**INSTRUCTIONS TO REPLACE THE SLOTTED COVER OF THE CURIX 60 AND CP1000 PROCESSING MACHINE, RADIOGRAPHIC; NSN 6525-01-345-6088 AND 6525-01-345-6089**

*Field Service Bulletin No. 4*

**Curix 60 / CP 1000**

### **MUST SAFETY MODIFICATION**

Figure 4

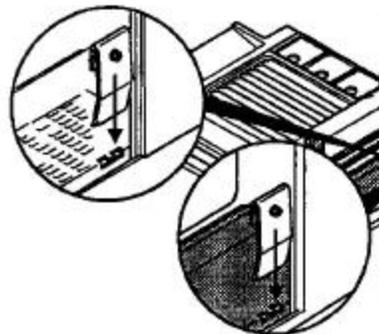
1. Insert the clamp bracket in the front recess of the box cover, (see Figure 4).
2. Fix the clamp bracket with the Phillips screw integrated in the bracket.

Figure 5

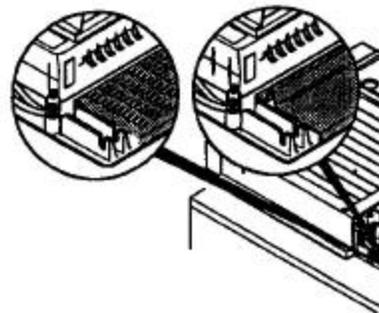
3. Undo the two Phillips screws on the strain relief (see Figure 5).

Figure 6

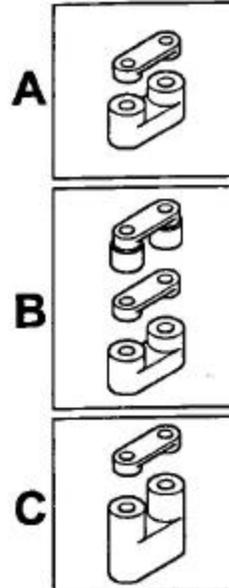
There are 3 different versions for the strain relief, A, B, and C, (see Figure 6).

4. Mount the spacer ring and the strain relief, enclosed in the shipment, to the strain relief present in the machine to obtain version B.

Position the two cables of the tank heater between the upper bridge and the screw connection of the strain relief. By the height increase of the strain relief the cables will be protected from possible chemical splashes.

Figure 8

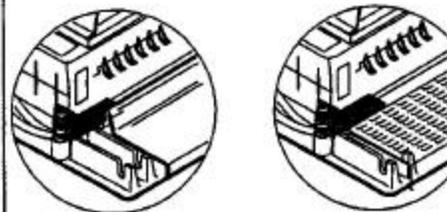
5. Mount the enclosed stop plate on the strain relief with the lug reaching across the cover of the electric box (see Figure 7 and 8).

4. Mount the enclosed stop plate on the strain relief with the lug reaching across the cover of the electric box (see Figure 7 and 8).

Abbildung 9

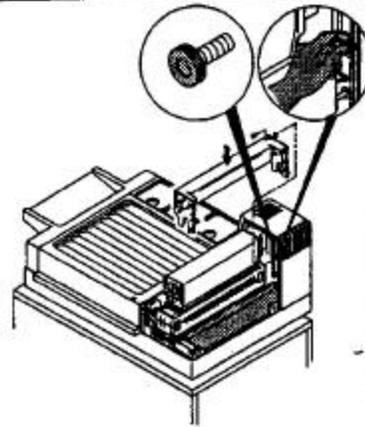
If a hex screw / Phillips screw was still used for fixing the exit section, please replace this screw by the enclosed knurled screw (see step 2 for the CP 1000 and Figure 9).
